APPLICATION NO.	FILING DATE .	FIRST NAMED INVENTOR	ATTORNEY DOCKET NO.	CONFIRMATION NO.
10/611,419	06/30/2003	Yee-Chung Fu	Q01-1041-US1 /11198.71 5714	
7590 08/22/2005			EXAMINER	
The Law Office of Steven G. Roeder			CHEN, TIANJIE	
5560 Chelsea Avenue La Jolla, CA 92037			ART UNIT	PAPER NUMBER
			2652	
		DATE MAILED: 08/22/2005

Non-Final Rejection

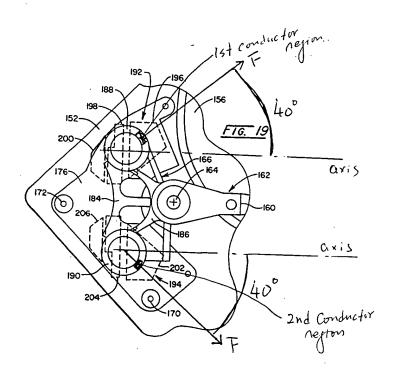
lines 44-64) that generates a magnetic field, and (ii) a first conductor region 188 (SeFig. 19 attached below with added marks) that cooperates with the magnet assembly to generate a first force that is directed at an angle having an absolute value that is greater than zero degrees and less than approximately 45 degrees relative to the longitudinal axis of the actuator assembly inherently at least partially offset the resultant force at the actuator hub.

Claim 2, Wason further shows a second conductor region 190 that cooperates with the magnet assembly to generate a second force (Fig. 19 above) that is directed at an angle having an absolute value that is greater than zero degrees and less than approximately 45 degrees relative to the longitudinal axis of the actuator assembly.
